**RE: Applications PR-2023-008710 & SI-2025-00082
U-Haul Site Plan
8200 Jefferson St NE, Albuquerque, NM**

Thank you for your time reviewing the U-Haul Site Plan application for the proposed development at 8200 Jefferson St NE. We received your comments dated February 11, 2025 and have addressed your comments. Below we have copied all your review comments and then provided written responses explain how each item was addressed.

DRAWN:	GBV	C3-10
CHECKED:	ARA

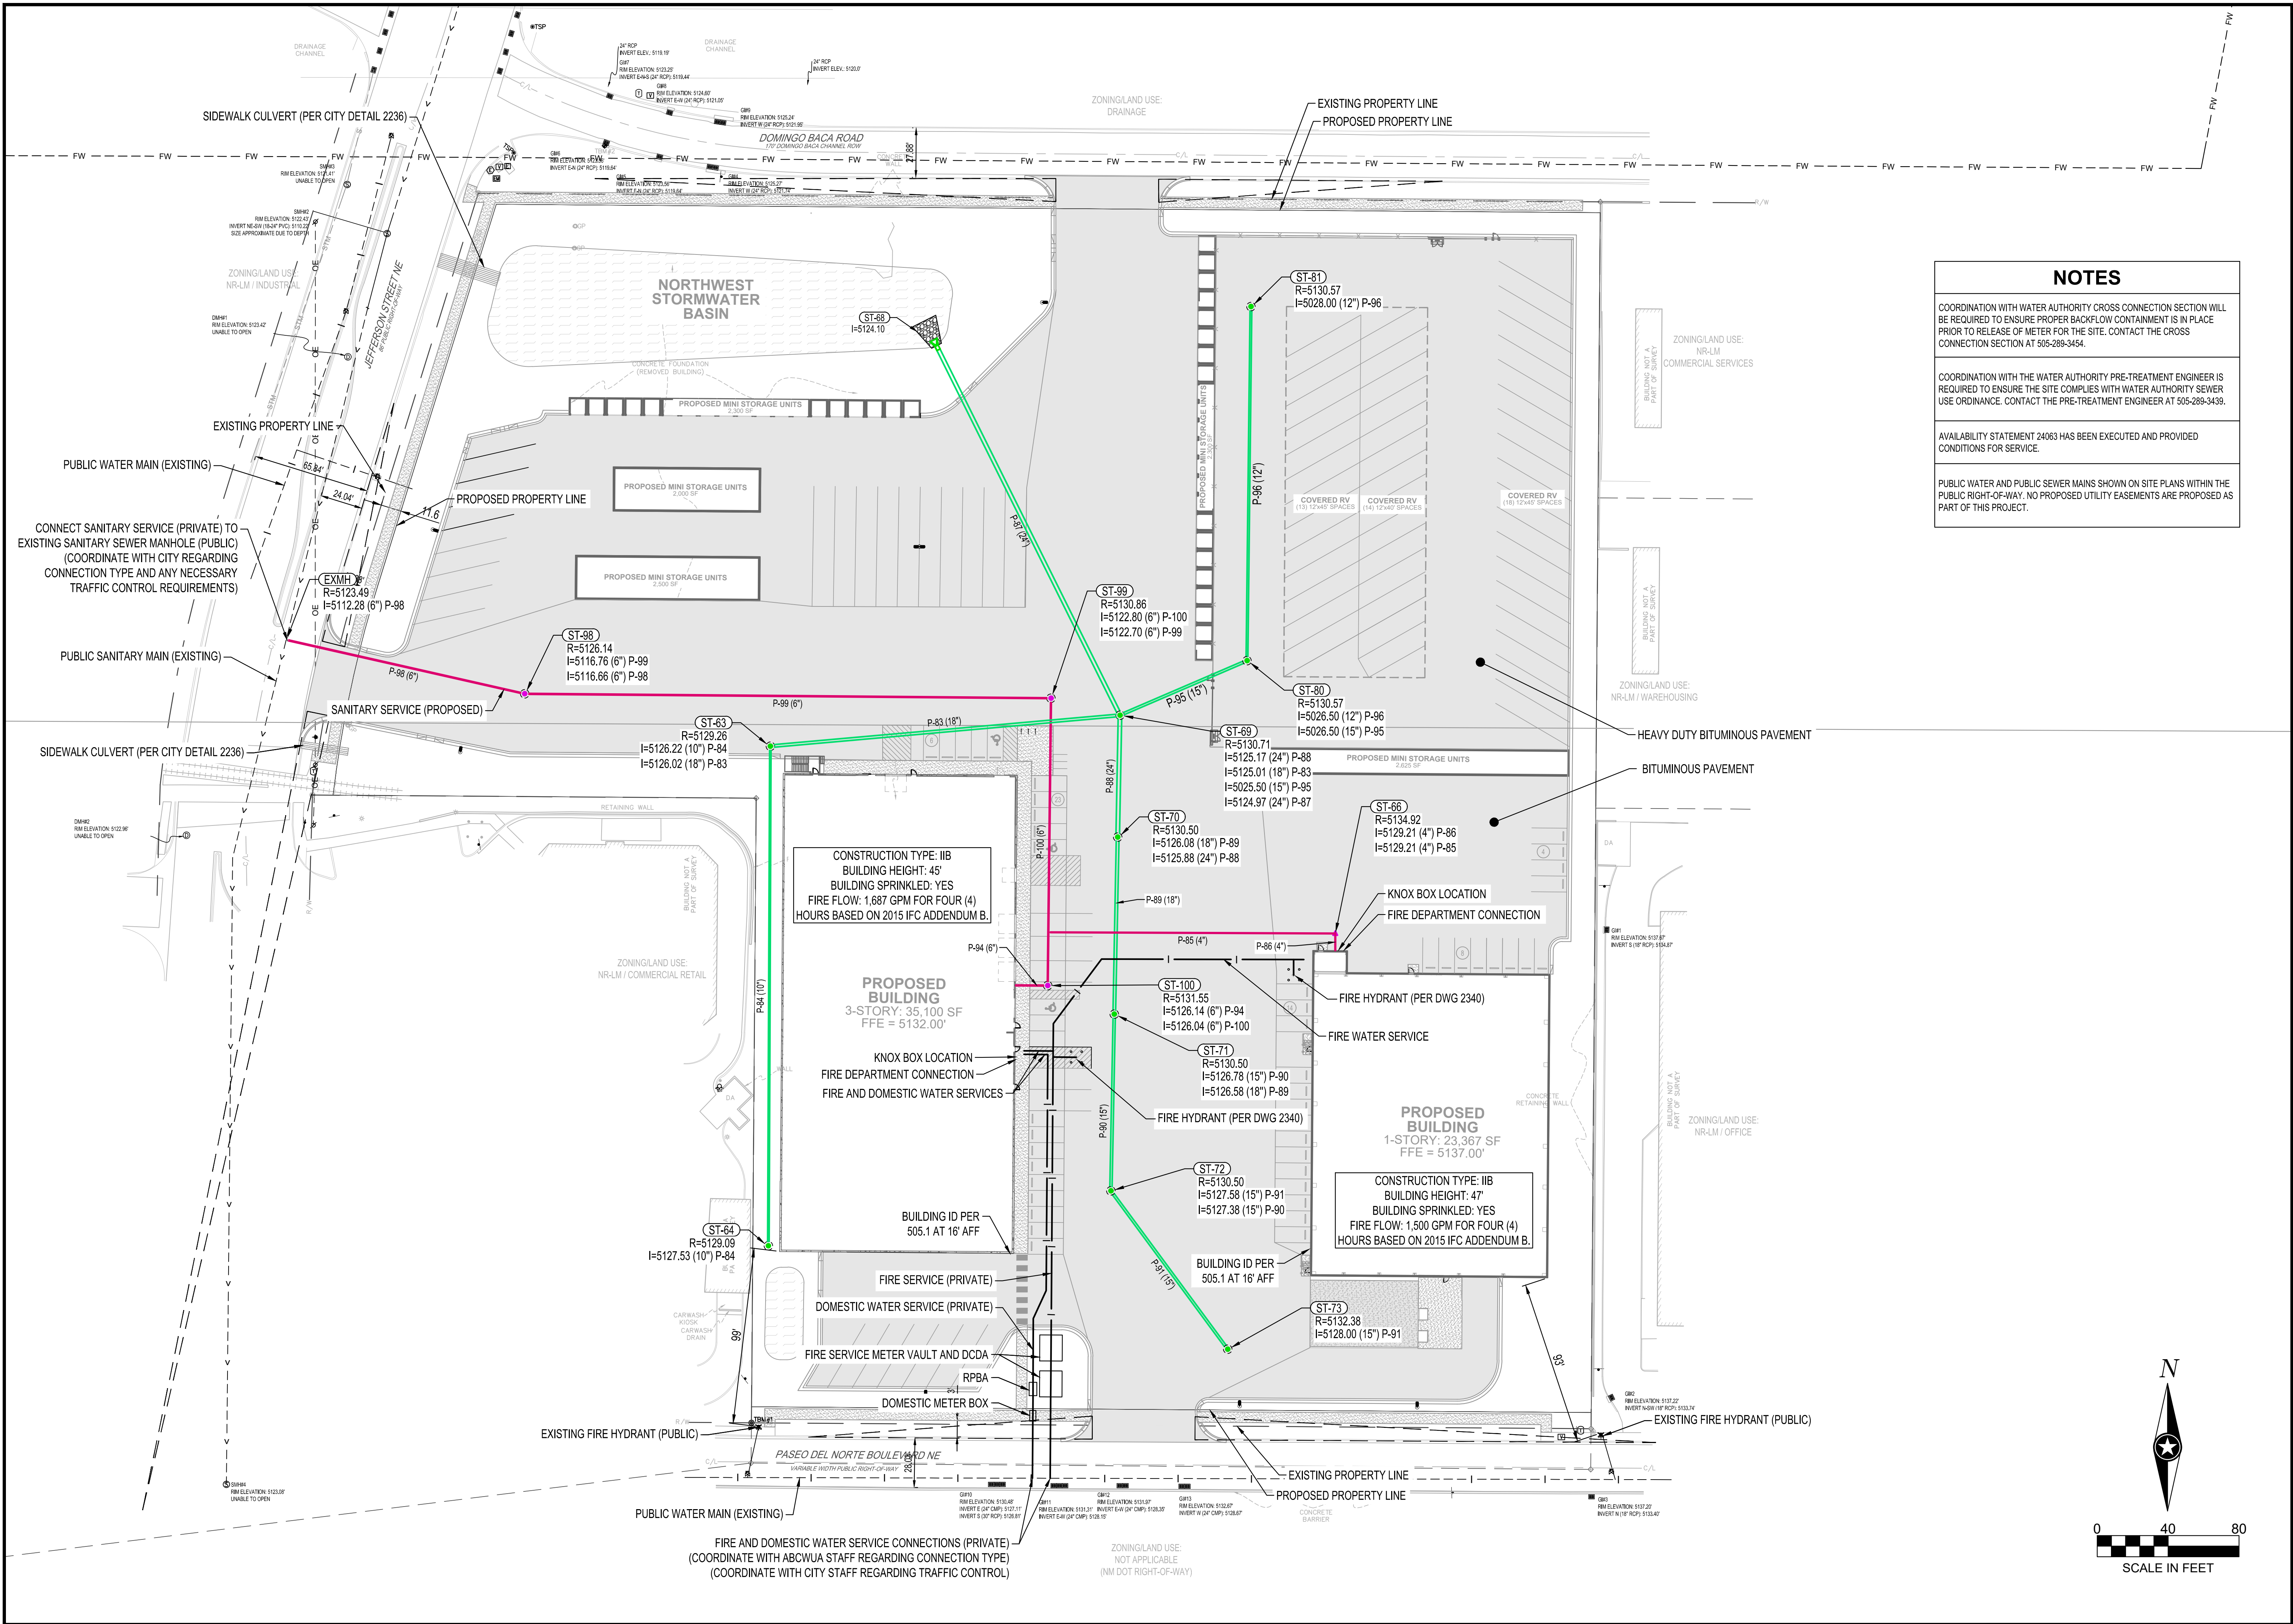
12. An outdoor seating area is required for a primary building(s) more than 30,000 s.f. See below for requirements.

ISG Response: This has been provided on the C3-10 Site Plan.

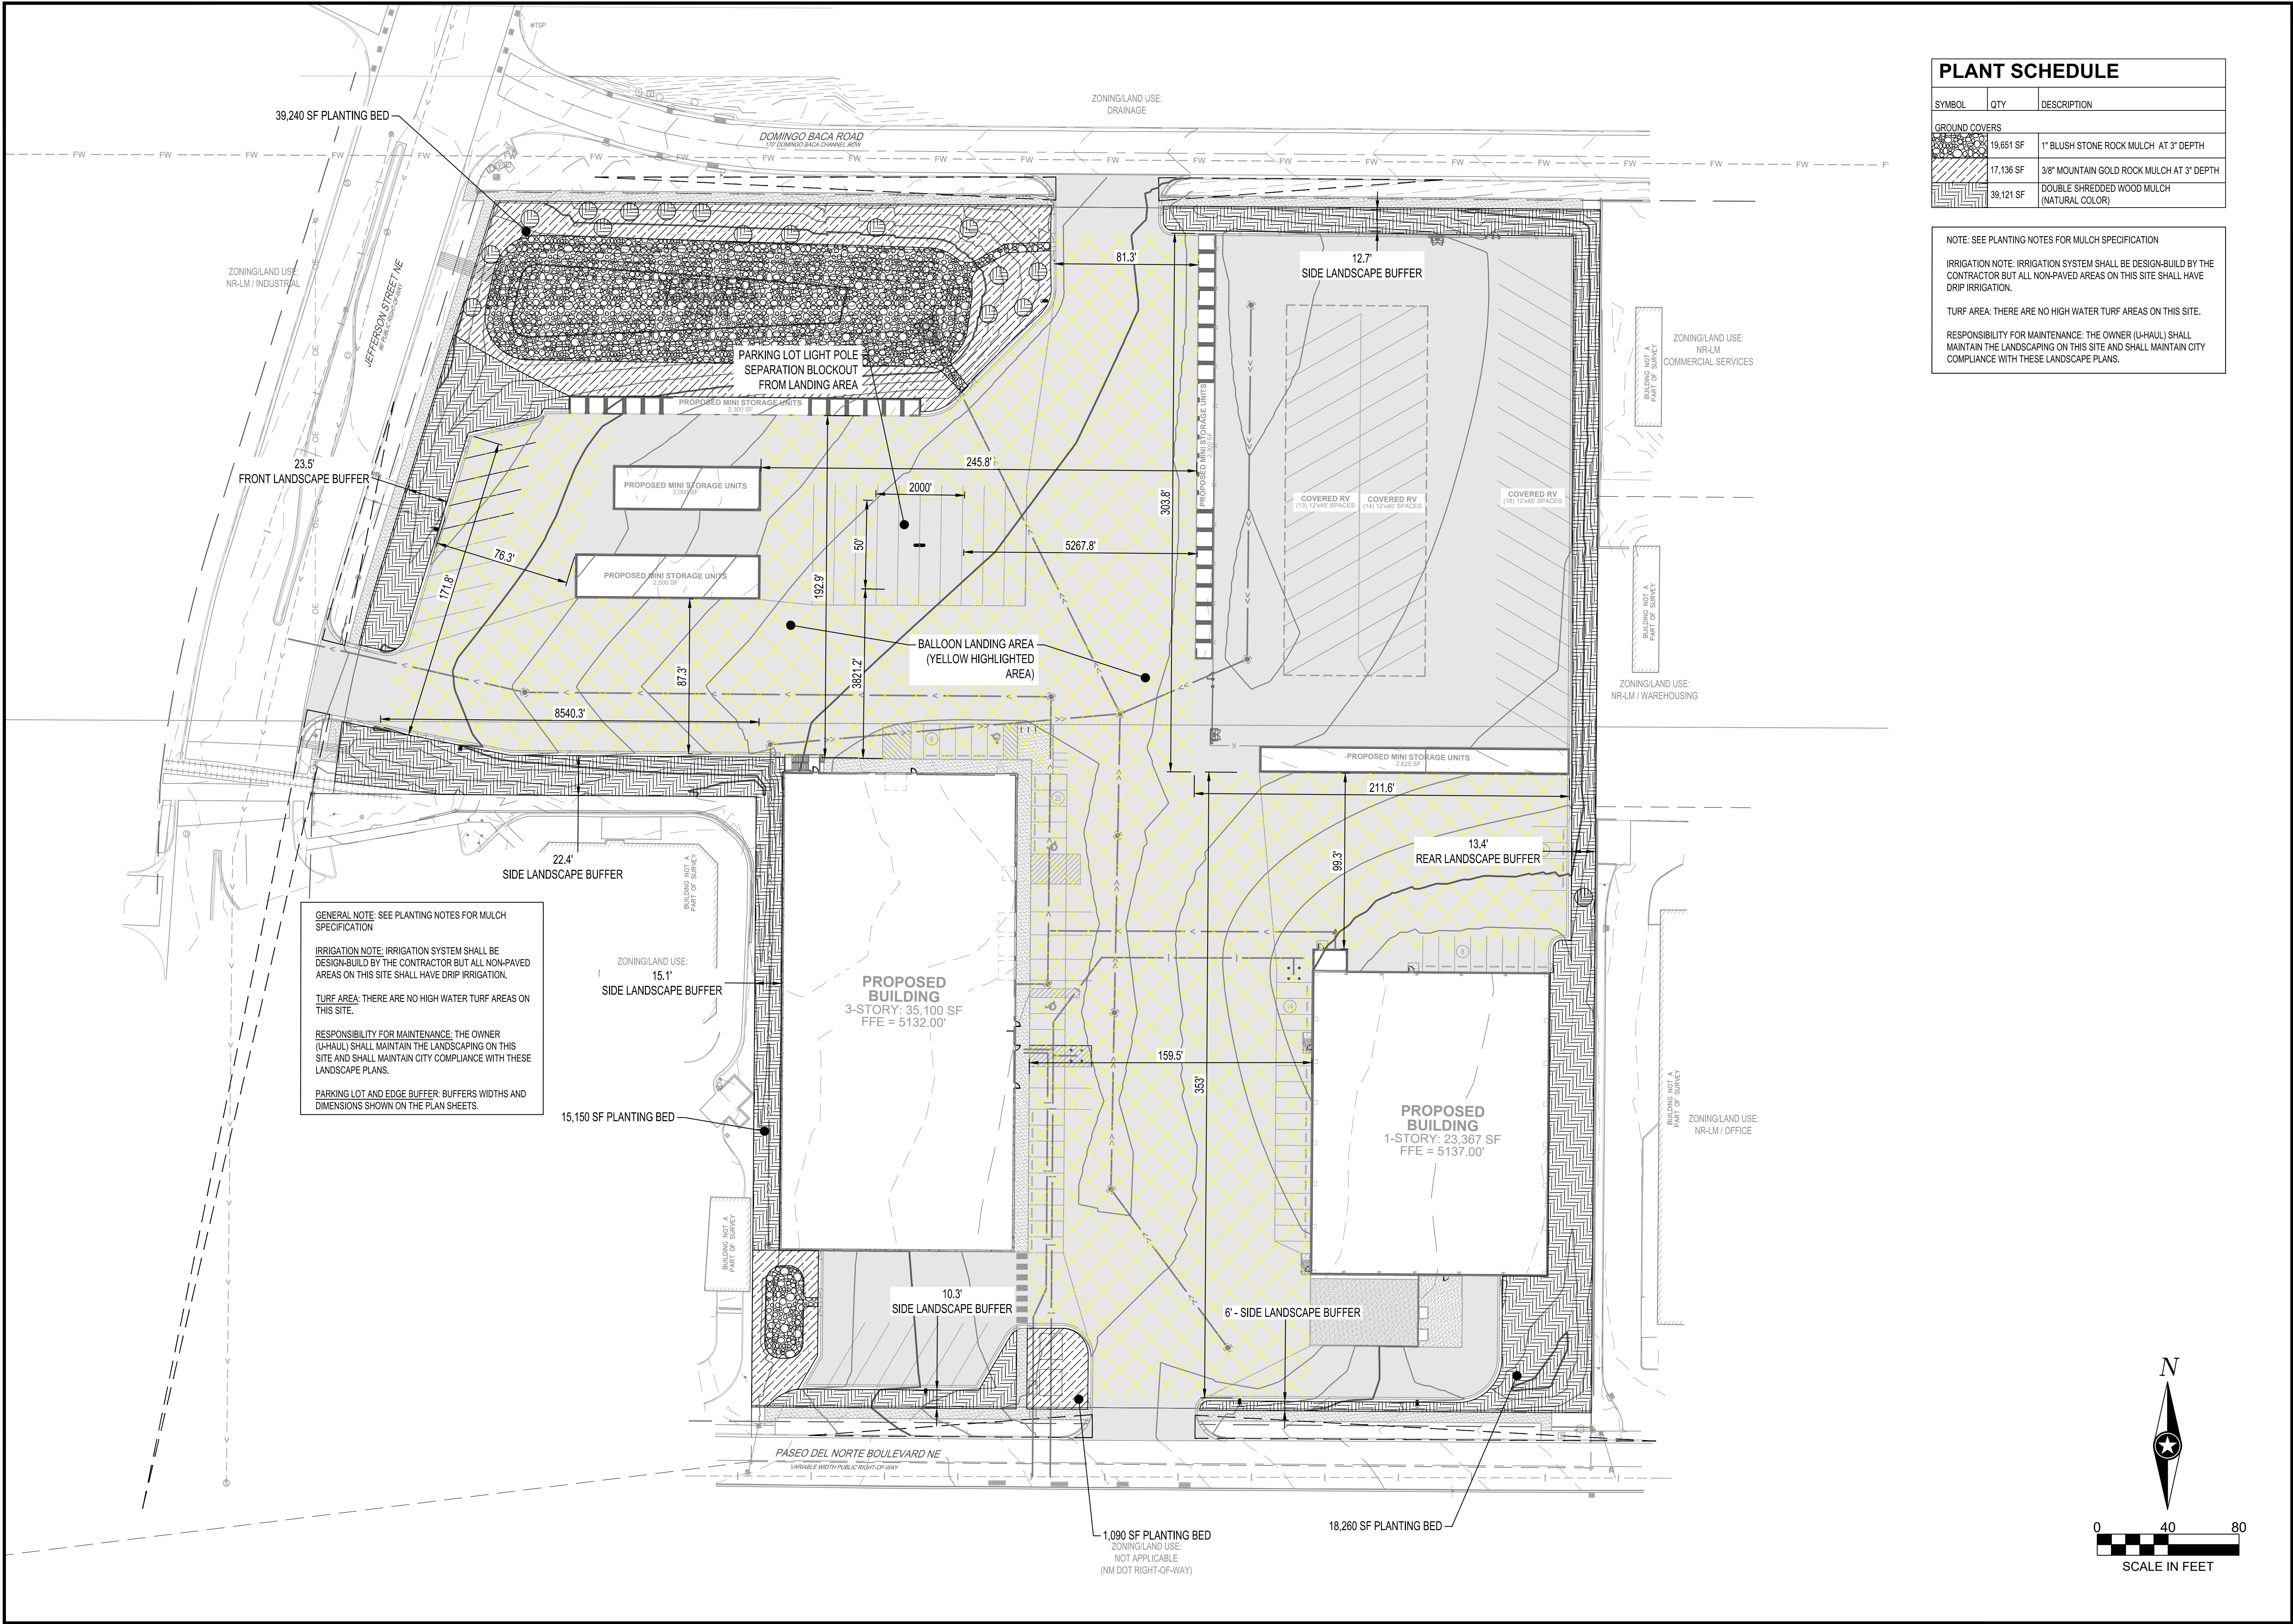
- b. Show existing public water and public sewer mains and any associated easements on the utility plan.

- e. Please add the following notes to the Master Utility Plan

1. Coordination with Water Authority Cross Connection Section will be required to ensure proper backflow containment is in place prior to release of meter for the site. Contact the Cross Connection Section at 505-289-3454.

- f. Please clearly label public vs. private infrastructure.

- g. Revise the note at the bottom of the sheet to say, “Fire and Domestic Water Service Connections (Coordinate with ABCWUA staff regarding connection type. Coordinate with City staff regarding Traffic Control)”.

ISG Response: This has been shown.

ISG Response: This has been shown.

ISG Response: This has been shown.

ISG Response: This has been noted.
